MEMORANDUM

DATE	31 March 2015
TO	Chair and Members -Sydney West Joint Regional Planning Panel Members
FROM	Robert Power - Independent Planning Assessor, WorleyParsons Services Pty Ltd
COPY	Anthony Newland – Parramatta City Council
SUBJECT	2014SYW047 DA: 12-14 Phillip Street, (Lennox Bridge car park and public access road) and 331A - 339 Church Street, PARRAMATTA

**RE: CHURCH STREET, PARRAMATTA – RIVERSIDE MIXED USE DEVELOPMENT
LOADING DOCK AND PHILLIP LANE DESIGN DETAILS**

PUBLIC DOMAIN PLAN
AERIAL VIEW
Project Number
13002
Drawing Number
L-001
Documentation Stage
Development Application
Revision
05

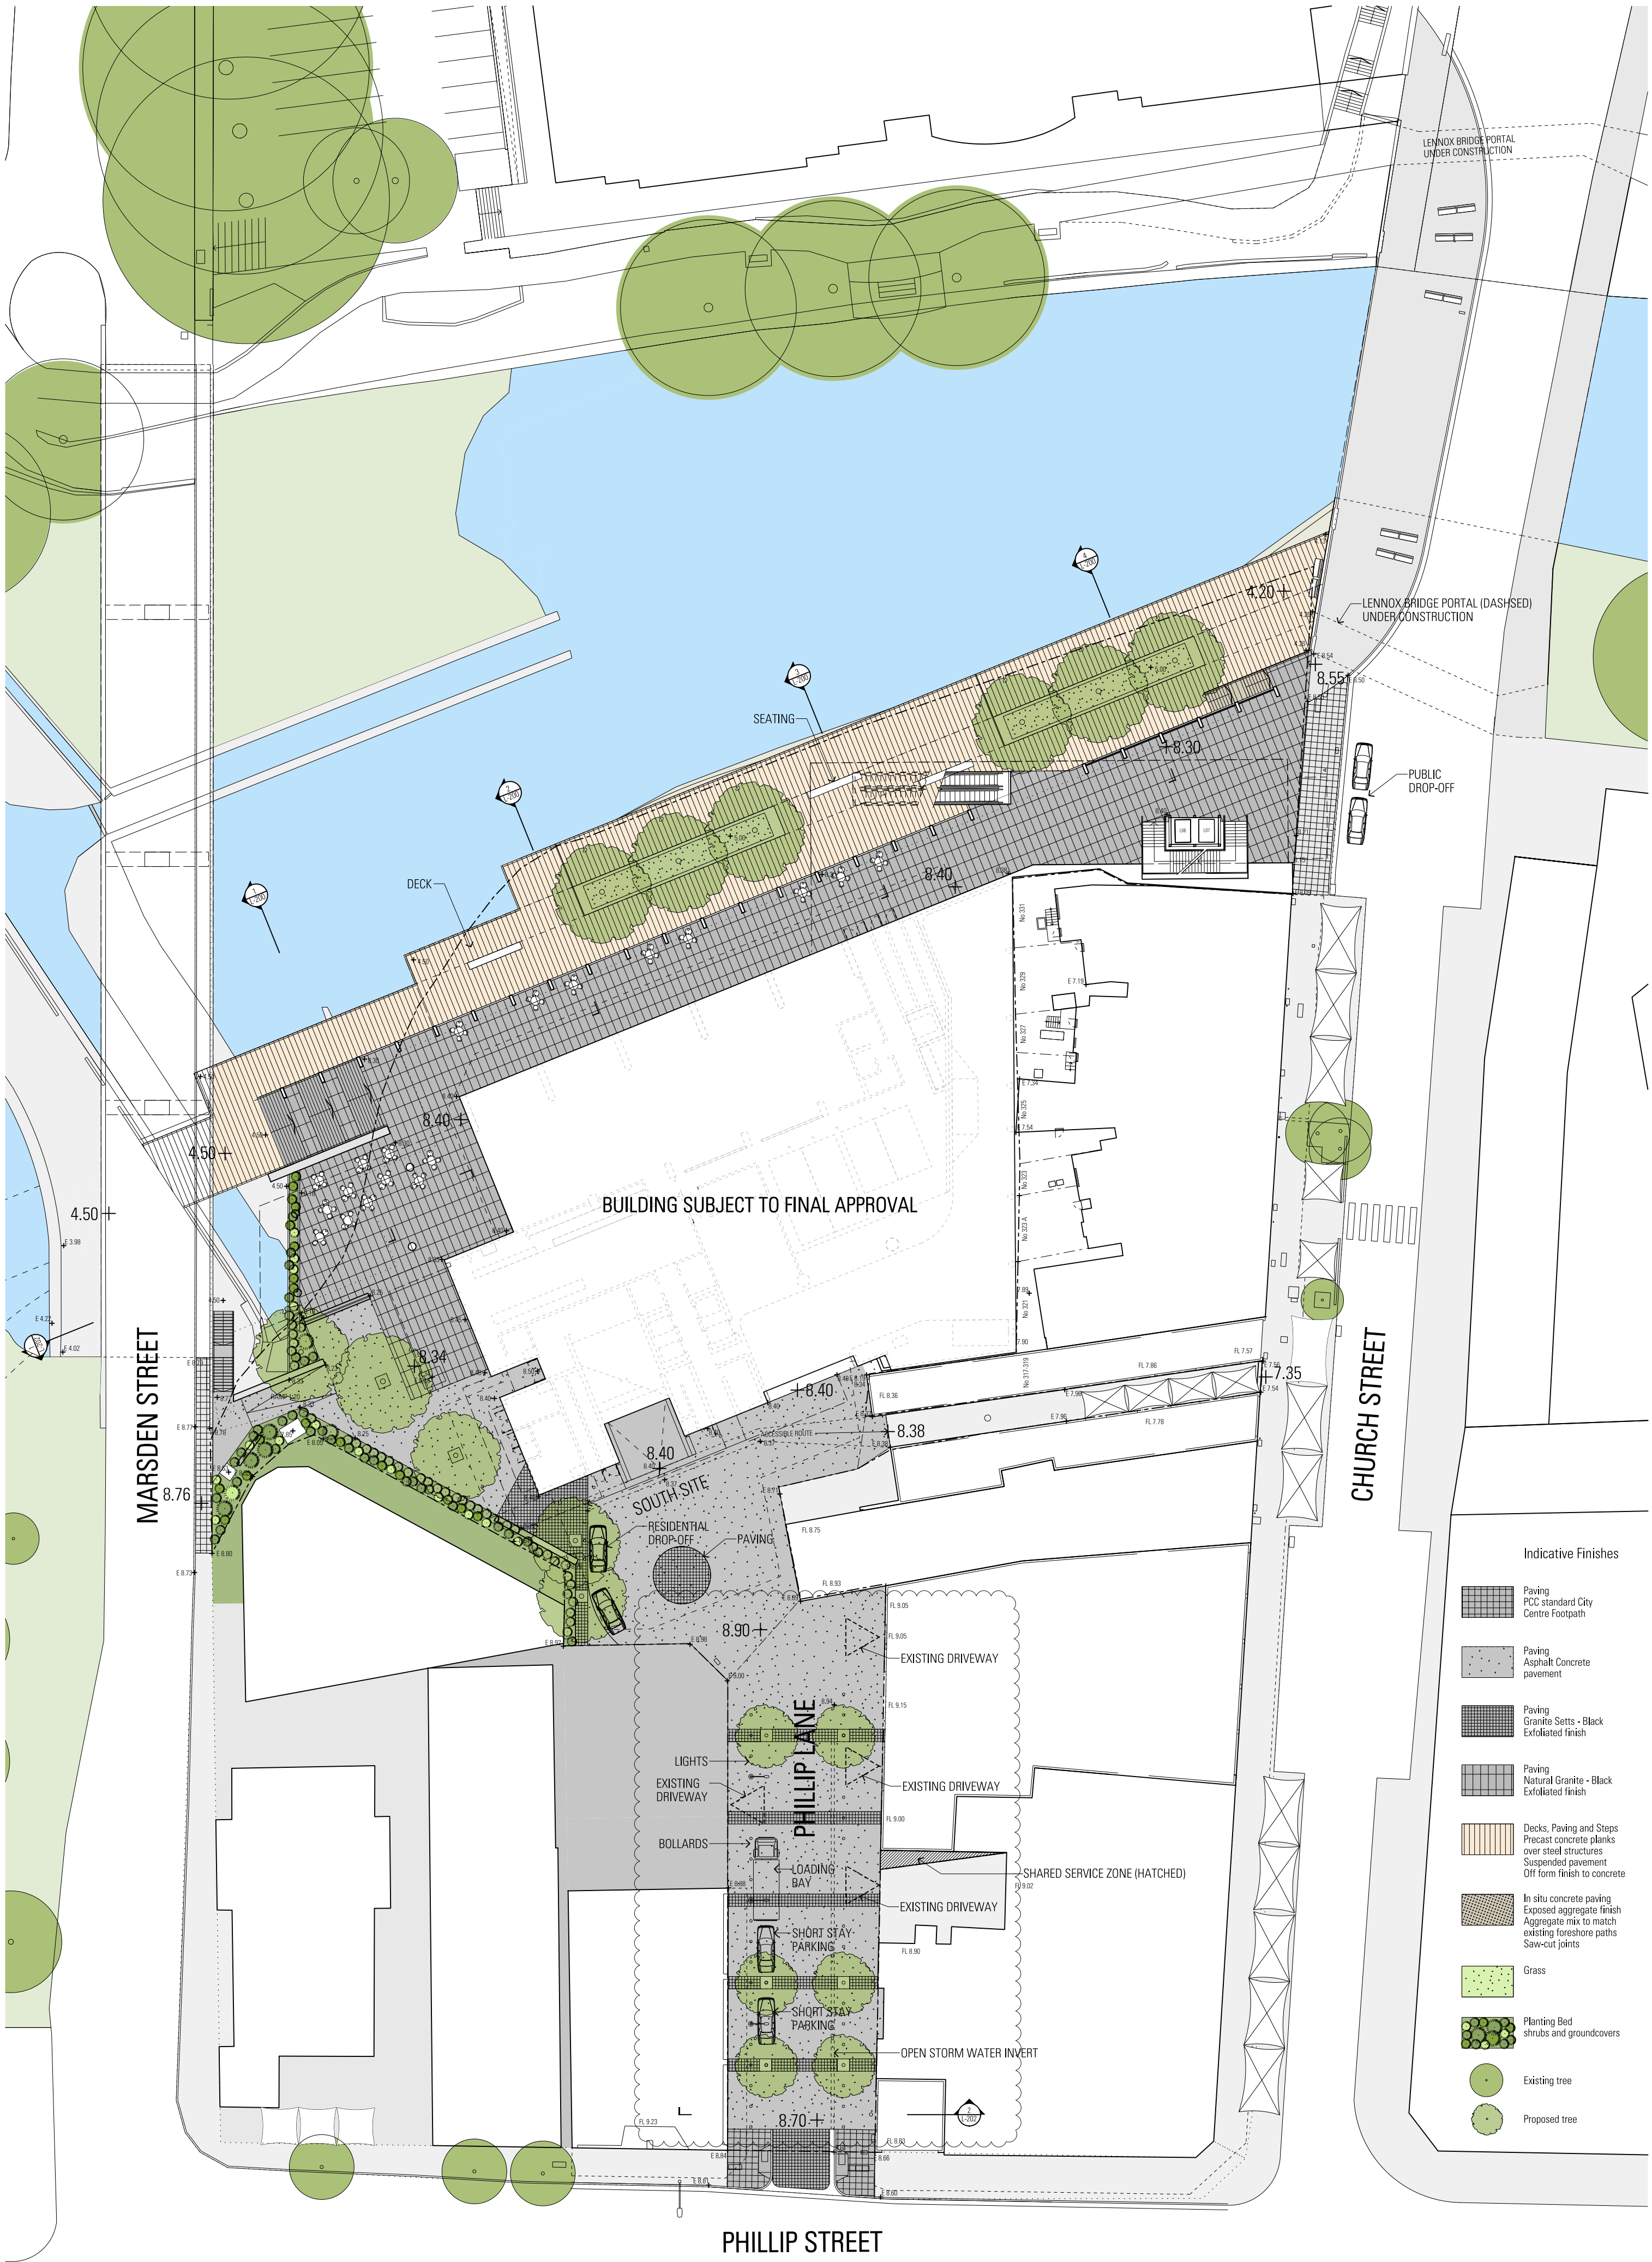
Since the issue of the Assessment Report to the JRPP, a request for additional information was sent to the Applicant in relation to the following matters:

- Public Domain Plan - show an Medium Rigid Vehicle (MRV) size vehicle instead of an Small Rigid Vehicle (SRV) for the proposed loading bay on the western side of Phillip Lane; and
- Swept path testing to demonstrate the capacity of Phillip Lane to accommodate two MRVs travelling along Phillip Lane directly alongside an MRV parked in the proposed loading bay on the western side of Phillip Lane.

In response to the request, the Applicant has submitted the following revised documents:

- Public Domain Plan Aerial View, prepared by JPW; and
- Loading Dock and Phillip Street Design Details, prepared by GTA Consultants, dated 31 March 2015.

Figure 1: Proposed Ground Level Site Layout

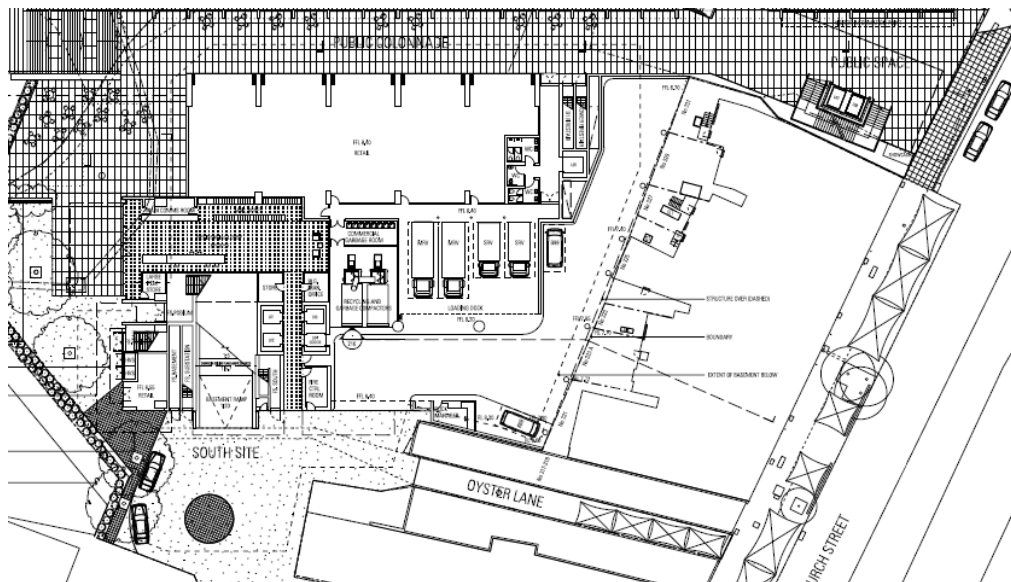
The proposed ground level site layout, including all loading dock facilities is illustrated in Figure 1.
